## Application for Variation of an Environmental Permit

# Hong Kong Offshore LNG Terminal Project

Proposal for Two (2) Jetting Machines

Proposed variation to the number of jetting machines during construction

Day 1 - Jetting Machine 1 commences (~ Sep 2021 tentative)

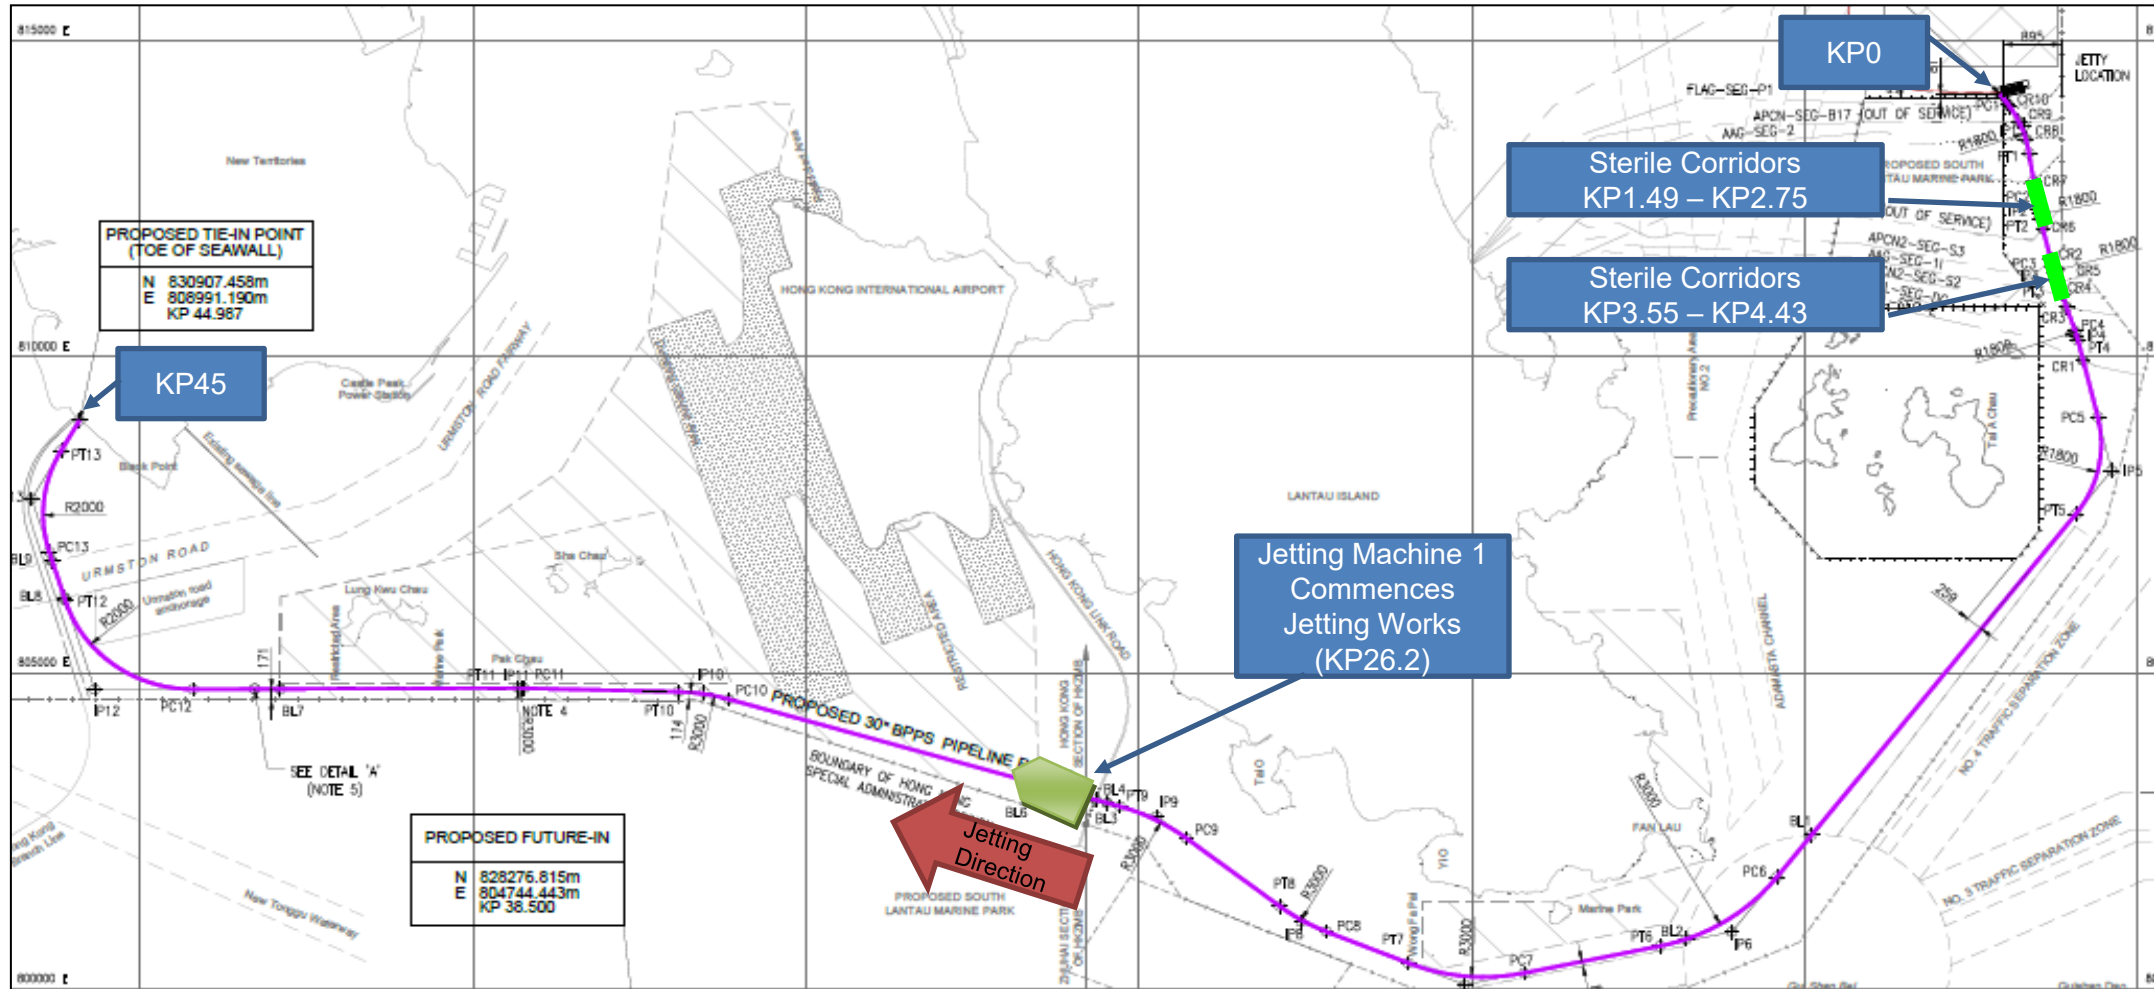
- Scenario 1: Both Jetting Machines 1 & 2 starts at KP26.2 and operates in opposite direction (see Slides 7 - 10)
  - Based on the latest construction schedule, Jetting Machine 1 for the North Section of the BPPS Pipeline is anticipated to commence jetting works first (see Slide 7). Jetting Machine 2 for the South Section is expected to commence later after Jetting Machine 1 has completed at least 5km of the North section and will be further away from each other as jetting works progress (see Slides 8 and 9).

# Proposed Variations (BPPS Pipeline) (Scenario 1)

Day 30 - Jetting Machine 1 Processing, Jetting Machine 2 commences (~ Oct 2021 tentative)

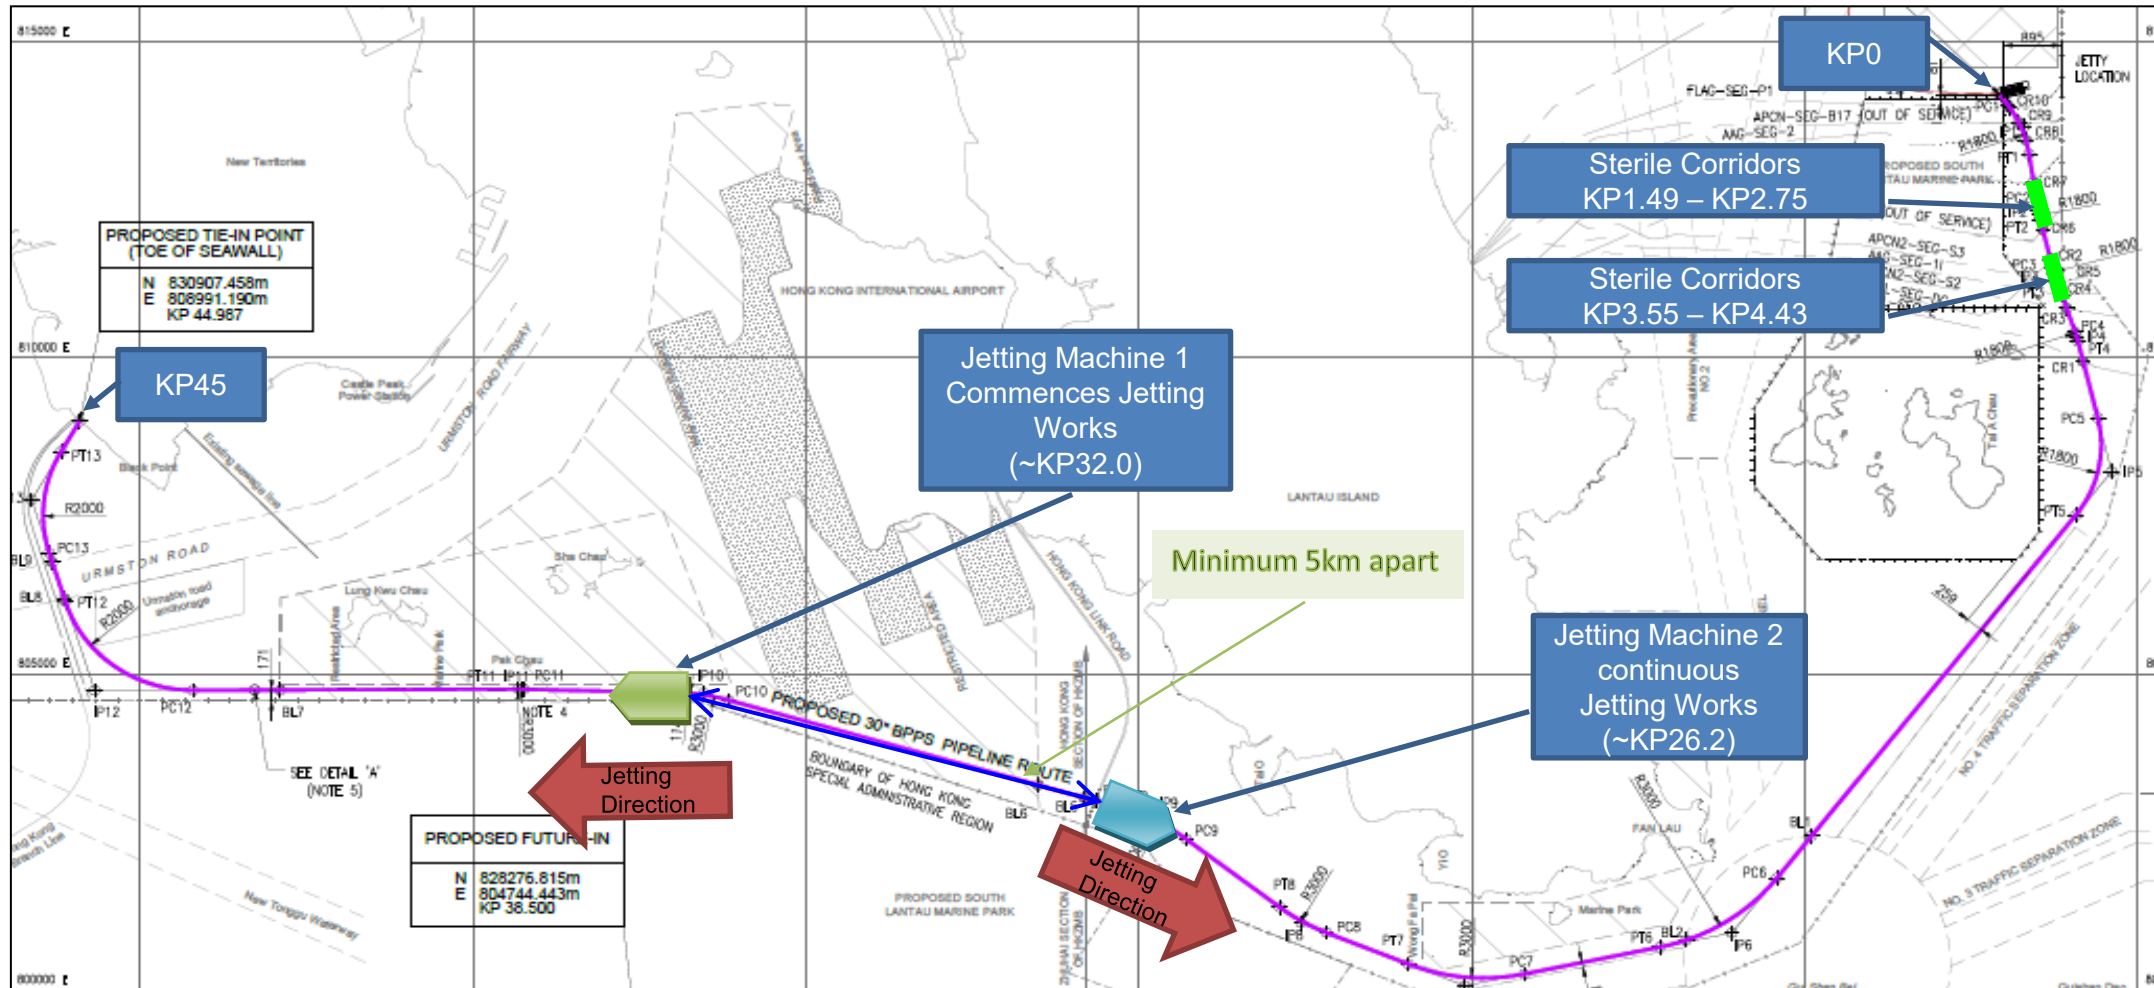
\* Since the 2 Jetting Machines will be jetting toward opposite direction, Jetting Machine 2 jetting toward the Jetty and Jetting Machine 1 toward the BPPS GRS, hence the **Worst-Case Scenario** will be at the first day when Jetting Machine 2 commences its works.

Day 100 - Jetting Machine 1 & 2 Processing (~ Dec 2021 tentative)

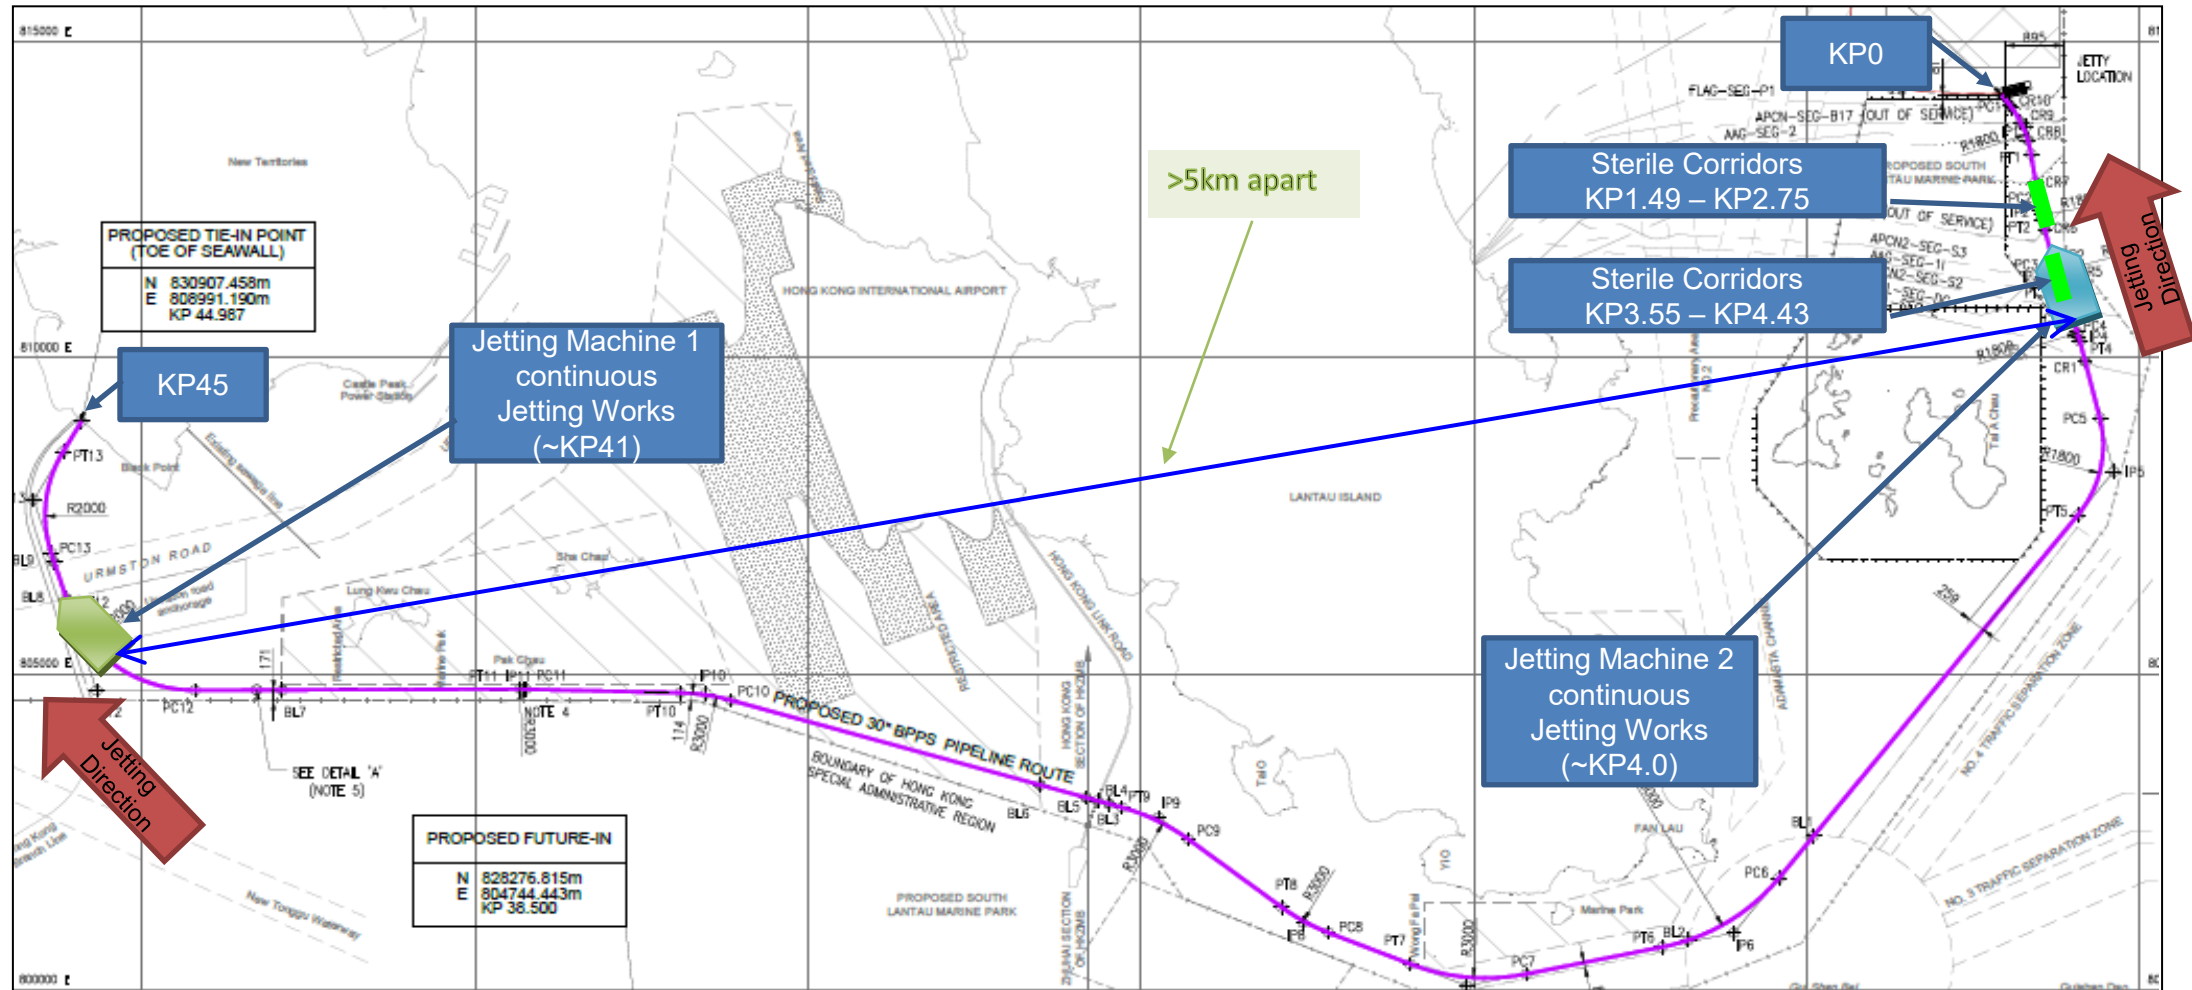
\* Jetting Machine 2 is expected to be approaching the Jetty in Jan 2022 tentatively.

Day 1 - Jetting Machine 1 commences (~ Sep 2021 tentative)

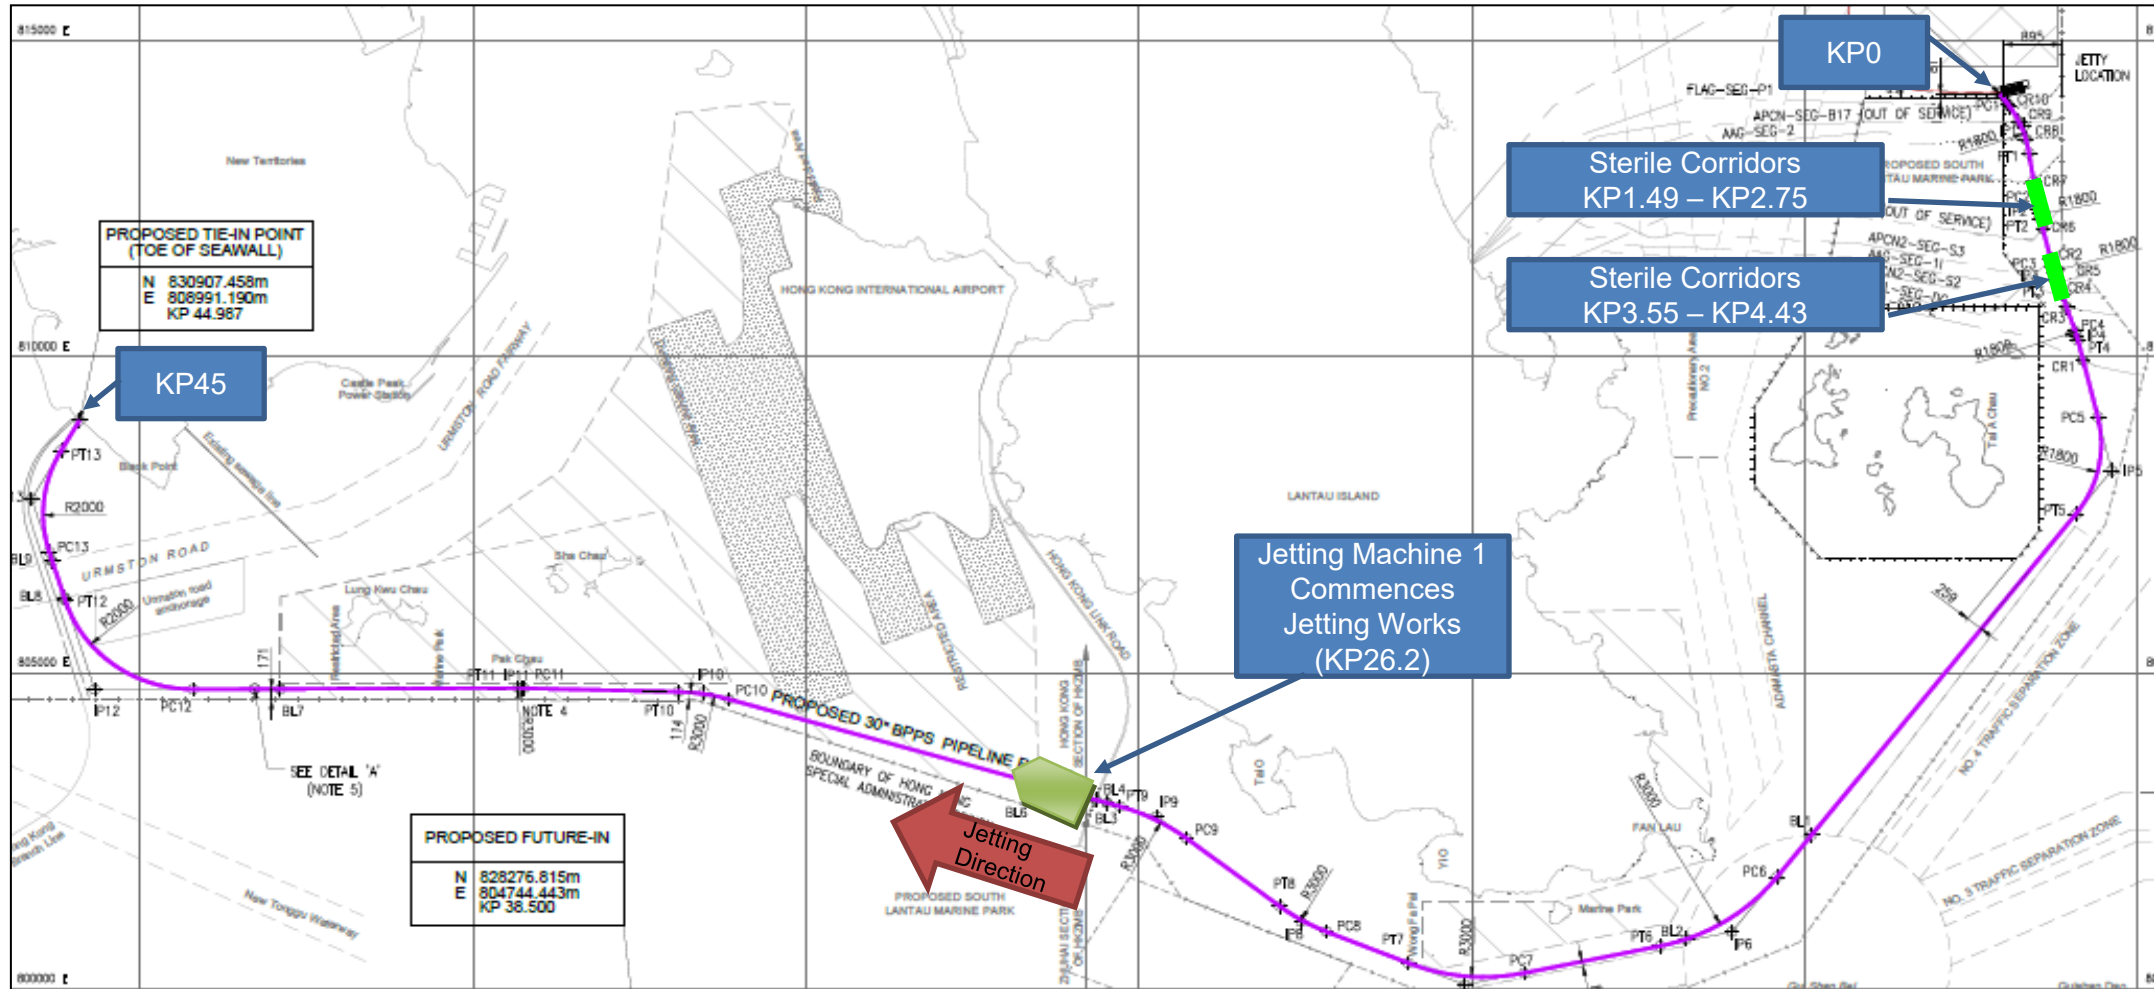
- Scenario 2: Jetting Machine 1 starts at KP26.2 and Jetting machine 2 commences at KP 0.0 and operates in the same direction (see Slides 11 - 14)
  - While both jetting machines will be jetting in the same direction, the separation distance of the two jetting machines will be maintained at least 5km apart. (see Slides 12 - 14)

Day 30 - Jetting Machine 1 Processing, Jetting Machine 2 commences (~ Early Oct 2021 tentative)

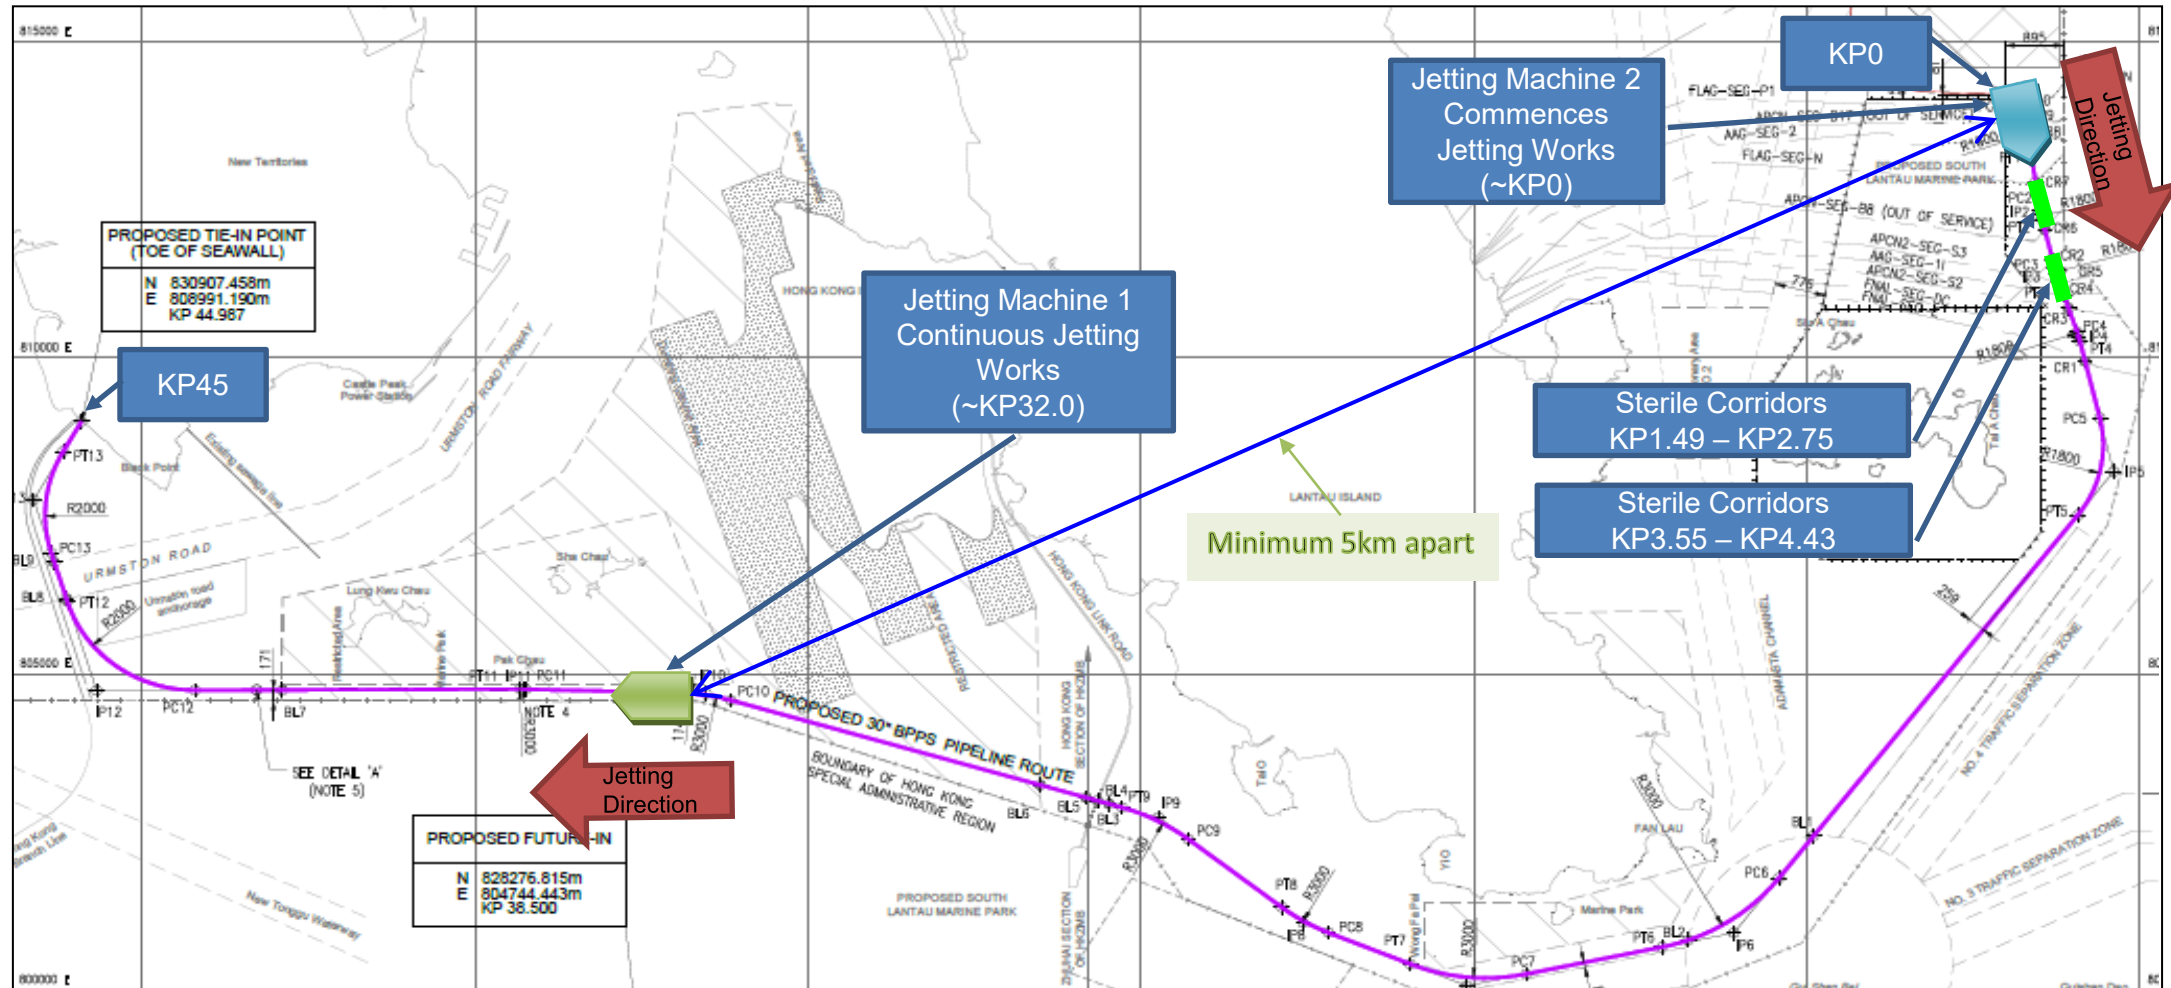
\* In Scenario 2, the Jetting Machine 2 will be commenced at the Jetty side which is approximately 30km apart from the Jetting Machine 1 and separated by the Lantau Island. Hence, cumulative impact from the 2 Jetting Machines is not expected.
